**Project: IEEE P802.15 Working Group for Wireless Personal Area Networks (WPANs)**

**Submission Title:** [ETRI's response to document 11/243/r0]

**Re:** [Response to the SB 1<sup>st</sup> recirculation for the IEEE 802.15.7 standard]

**Purpose:** [To resolve the comments 308 and 312 of the SB 1<sup>st</sup> recirculation ]

## New Clause 7.1.17 (CID 635)

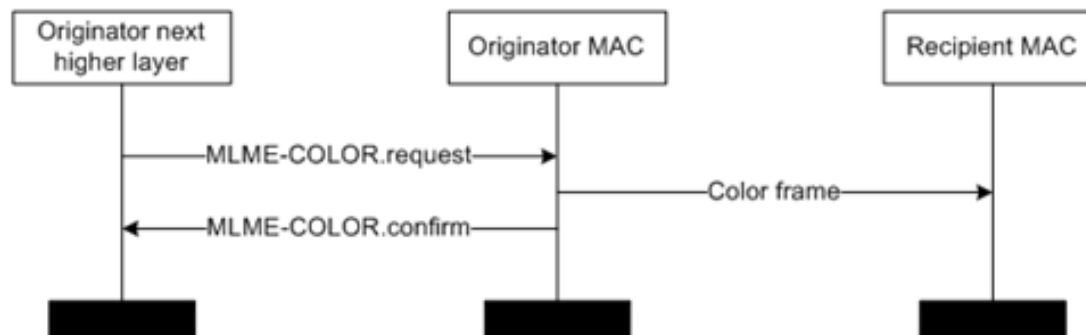
- ETRI had already suggested the separate primitives (MLME\_Color.request and MLME\_Color.confirm) on Beijing Meeting on May last year to support the color function, the related mechanism, and the related text.
- See the document 10/348/r0.
- We had an experience which the document 10/348/r0 had continued to be discussed during June last year.
- See the conference call minutes (doc. 10/388/r6)
- We finally agreed to the conclusion that the color functions are supported only by the primitives (MLME-associate, MLME-scan, MLME-disassociate and so on), which already exist, not the separate primitives, on San Jose meeting on August last year.
